Determination 2021/002

Regarding the proposed refusal of an amendment to a building consent relating to an intermediate floor in a new building at 8 Cygnet Drive, Bell Block, New Plymouth

Summary

Fig 1: Copy of fire egress plan F1.01 issue 2 – shaded area indicates proposed intermediate floor (not to scale)

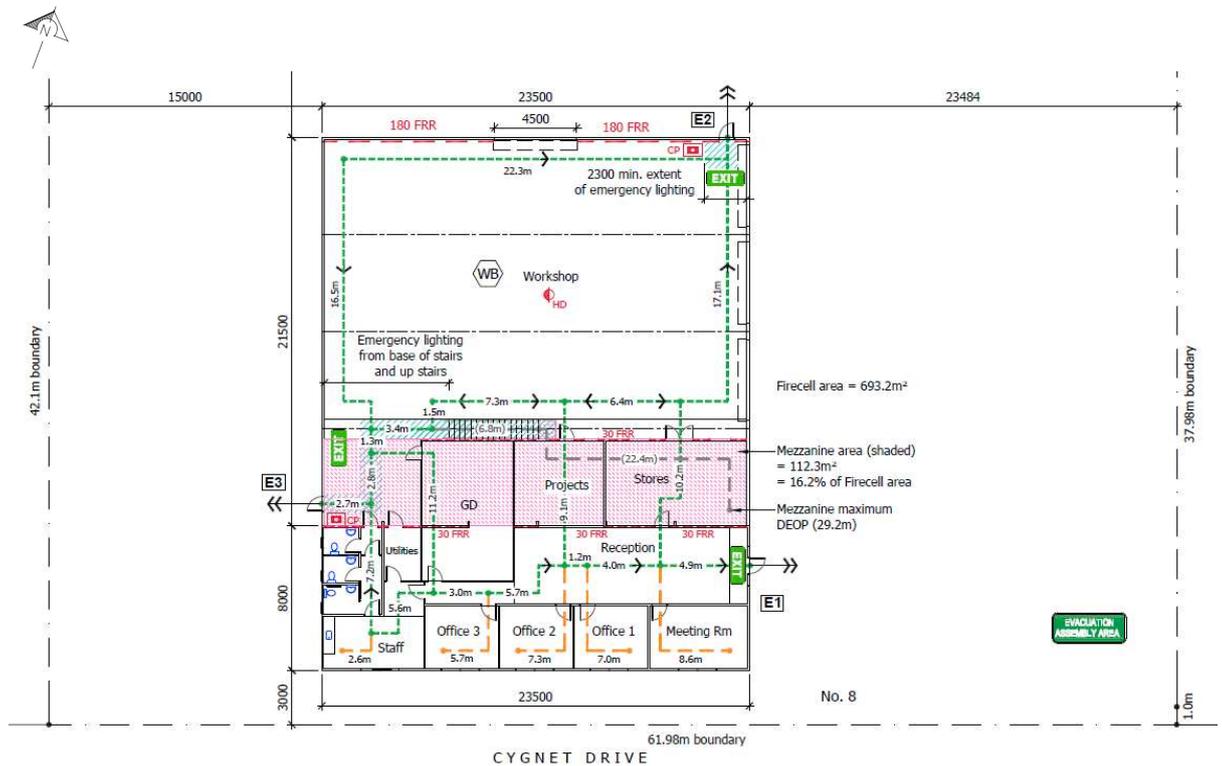
The proposed mezzanine floor exceeds 35m² permitted in buildings capable of storage height above 3m. Revise design to comply with cited acceptable solution or

The justification from the fire engineer regarding the applicability of risk group is not accepted. Revise fire design to acknowledge either;

- Alternative solution based on C/AS2 risk group WB¹⁵ or
- [Specific Engineered Design]/VM2 fire design.

- Extension of office area and addition of mezzanine floor...Intermediate floor sizing inconsistent with C/AS2 4.13.7...Fire [engineer’s] response not accepted as correct interpretation of classified use and purpose group...removed mezzanine from scope.

- the authority did not correctly consider the change of the intended use of the building at the time the building consent amendment application was received by the authority;
- the authority was correct to propose to refuse the building consent amendment application for a new intermediate floor, based on the incomplete information it had before it when the decision was made, and I confirm that decision.
